**Pipeline and Hazardous  
Materials Safety  
Administration**

Re: PHMSA Docket No. 2011-0075

**FINAL DECISION**

Det Norske Veritas (USA), Inc. (Petitioner or DNV) has filed a petition for approval (Petition) of the PHAST-UDM (Process Hazard Analysis Software Tool – Unified Dispersion Model) under 49 C.F.R. §§ 190.9 and 193.2059(a).<sup>1</sup> On July 12, 2011, the Pipeline and Hazardous Materials Safety Administration (PHMSA) issued a Draft Decision proposing to approve the Petition and providing the public with a 30-day comment period. After reviewing those comments and making appropriate modifications to the determinations in the Draft Decision, PHMSA is approving the Petition in this Final Decision.

**Figure 1 Predicted Concentration against Measured Concentration**

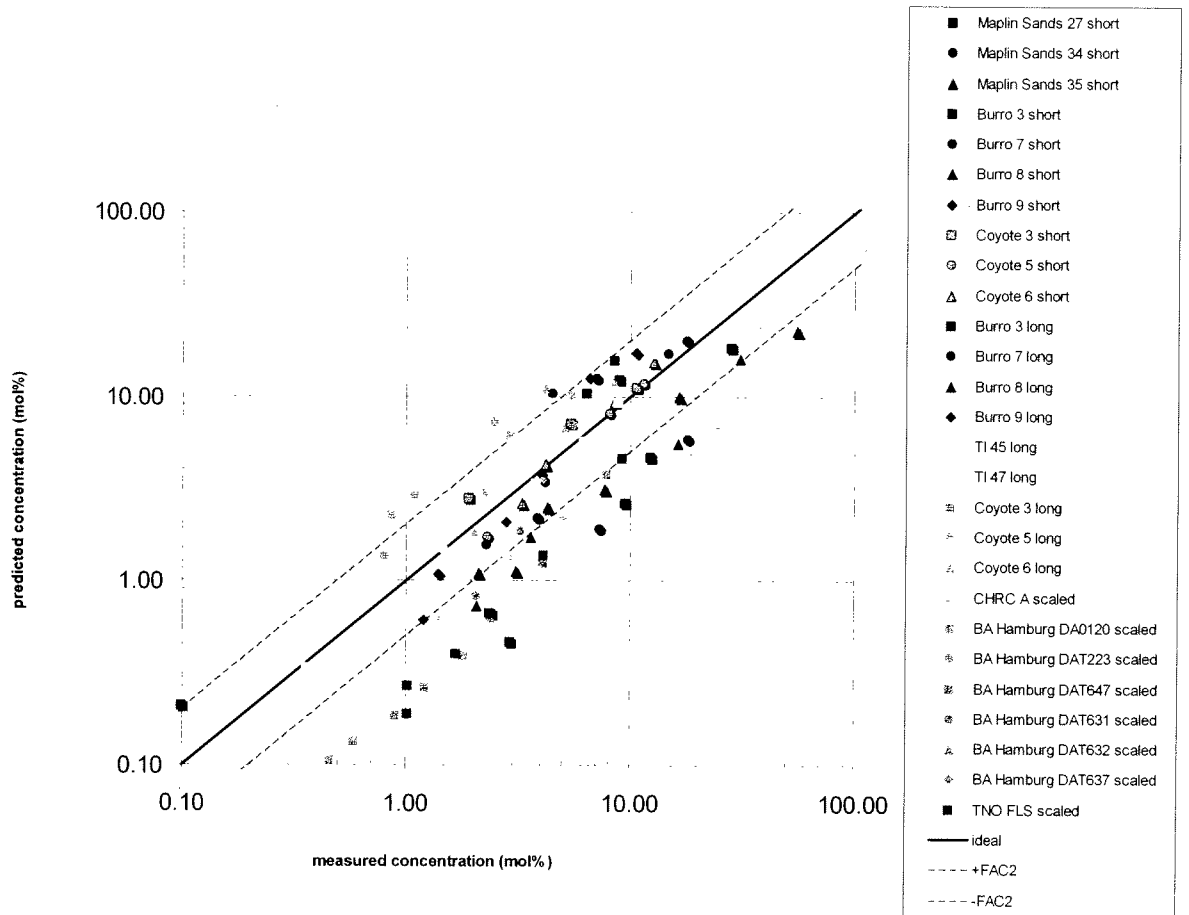
UDM is generally in good agreement for maximum arc-wise concentrations for field trials with the exception of the Maplin Sands trials and Burro 8. A large percentage of the data is within a factor of 2. Field trials over land with short time averages may be the most pertinent data set for onshore LNG flammable hazards, and agree the best with the data, often within the experimental uncertainty bounds. The over-prediction is generally more severe for field trials with long time averages with the exception of Burro 8. The higher CSF for longer time averages can be attributed to the lesser sensitivity the model shows to longer time averages compared to the sensitivity the averaging of the experimental data exhibits. UDM becomes slightly less conservative as the vapor cloud disperses downwind. UDM may be under-predictive by a factor of 2 or more for dispersion over water (i.e., Maplin Sands trials) and may be under-predictive by a factor of 2 for low wind speeds (<2 m/s) and high atmospheric stabilities (F stability), which is

especially pertinent to the current federal regulations under 49 C.F.R. Part 193. UDM is generally under-predictive for wind tunnel experiments often by a factor of 3 or more. Nearly all wind tunnel data was under-predicted with the majority of the data being under-predicted by more than a factor of 3.

Although the maximum arc-wise concentrations for field trials over land are most applicable to the scenarios considered under the 49 C.F.R. Part 193 regulations and generally show over-prediction, there are uncertainties that indicate potential under-prediction by a factor of 2 (or more). Until these uncertainties are resolved, it is recommended that at least a safety factor of 2 be used when evaluating predicted maximum arc-wise concentrations from UDM. Alternatively, a distance safety factor of 2 may be used.
